Groundwater Application Review Summary Form

Application # G- 19419

GW Reviewer Mitra Khadka/Travis Brown Date Review Completed: 11/14/2024

TO: Water Rights Section Date 11/14/2024
 FROM: Groundwater Section Mitra Khadka/Travis Brown
 Reviewer's Name
 SUBJECT: Application G- 19419 Supersedes review of _____
 Date of Review(s)

Water-Level Measurements in Nearby Wells

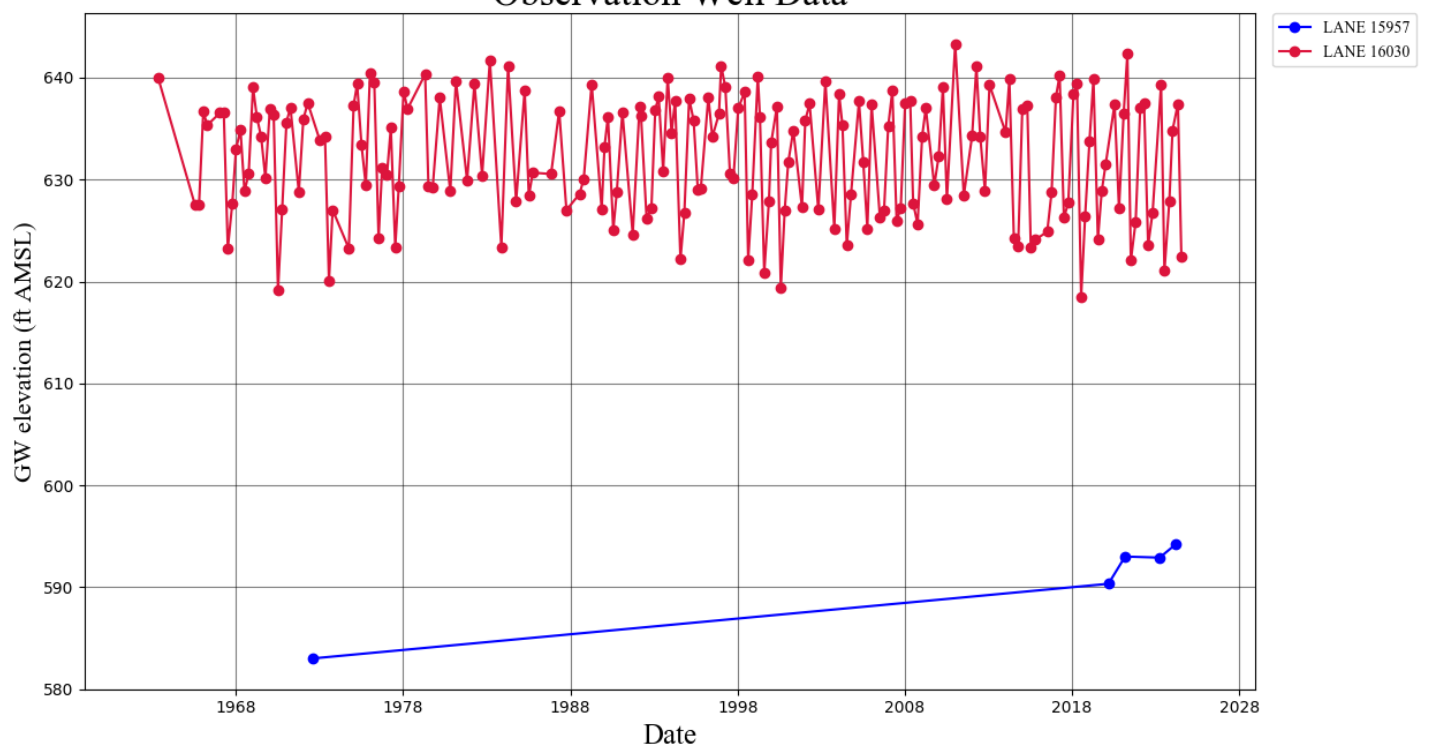
Nearby State Observation Well (LANE 16030), located approximately 0.5 mile to the southeast is the only well with current and log-term water level measurements within the three miles of the proposed POA. The LANE 16030 hydrograph shows a reasonably stable groundwater conditions with a seasonal fluctuation of up to ~15-20 ft over the period of record (see attached hydrograph).

Theis Interference Analysis**Theis Time-Drawdown Worksheet**

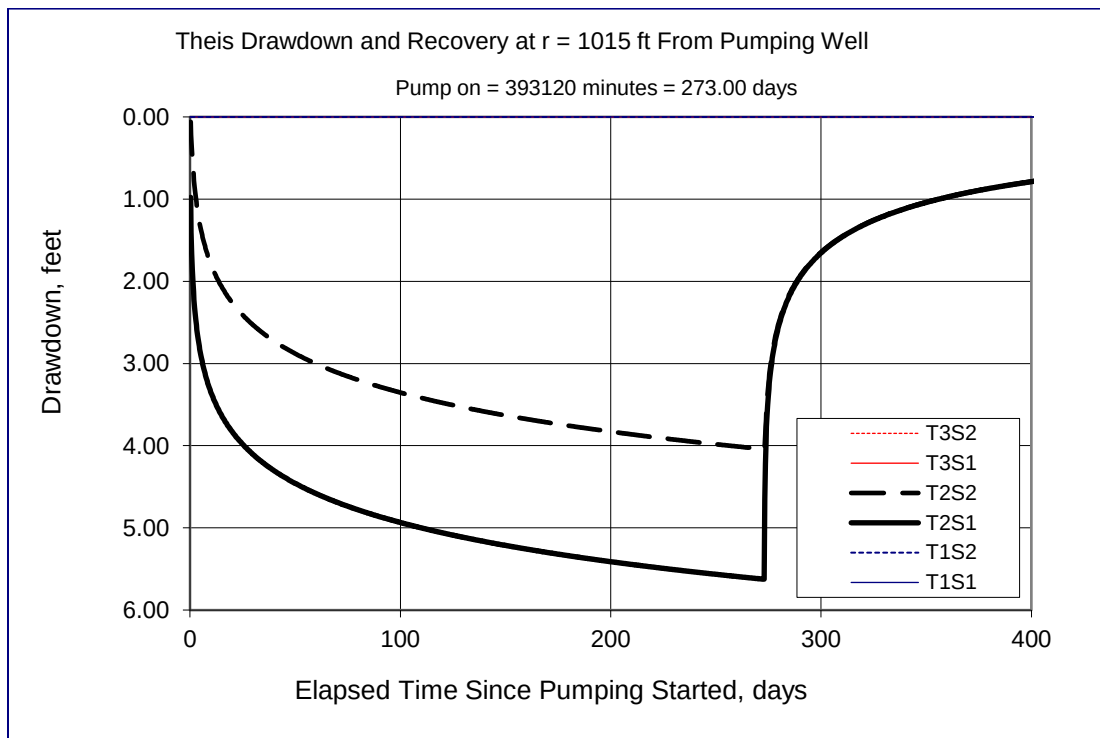
The nearest groundwater user to the proposed POA appears to LANE 15957 under Permit: G18207, located ~ 1015 ft to the northwest. Interference with LANE 15957 was quantitatively estimated using a Theis drawdown analysis model. Hydraulic parameters used for the analysis were derived from regional data and studies (Pumping Test Reports; Conlon et al., 2005; Woodward et al., 1998). The analysis estimates maximum drawdown to be ~6 ft at LANE 15957 after 273 days of continuous pumping at the maximum requested rate (see attached Well to Well Interference). Results indicate that the proposed use of

groundwater is not likely to cause Substantial and Undue Interference with neighboring wells that meets a definition of well-to-well injury.
